UNITED STATES PATENT AND TRADEMARK OFFICE

Office Action Summary

09/762,223

DETAILED ACTION

Figure 10

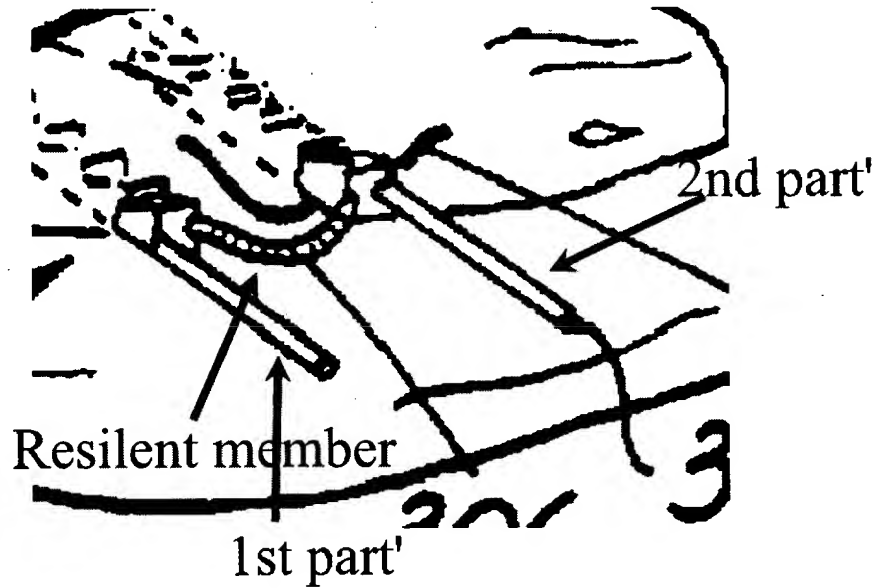
17. Regarding claim 68, the elongate member of the Green device has the capability of being in an open configuration, figure 14, and a retaining configuration, figure 1, where in the 1st and 2nd parts are closely spaced, wherein the device is biased towards the closed configuration. Further, the elongate member extends between the first and second element and is connected between the first and second ends. The modified Green device could be inserted into a graft-bearing artery to pierce the graft and artery. Once the device, part 1, is completely pushed through the artery, the graft and artery would be maintained between the first and second part where in the device would be in the closed position.

Figure 14

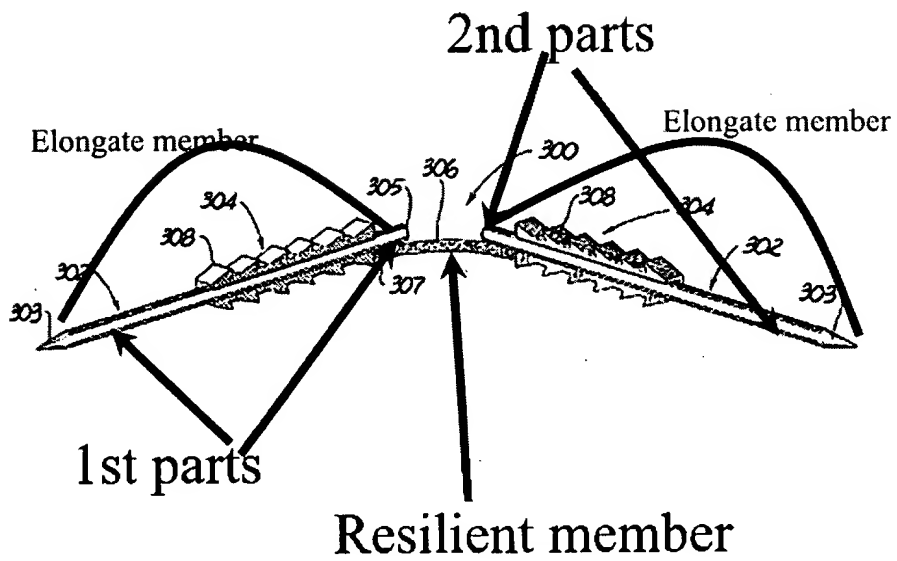
18. Regarding claim 69, the fixator has 2 parts that are sharpened, allowing it to pierce an artery and a graft (see figure 14).
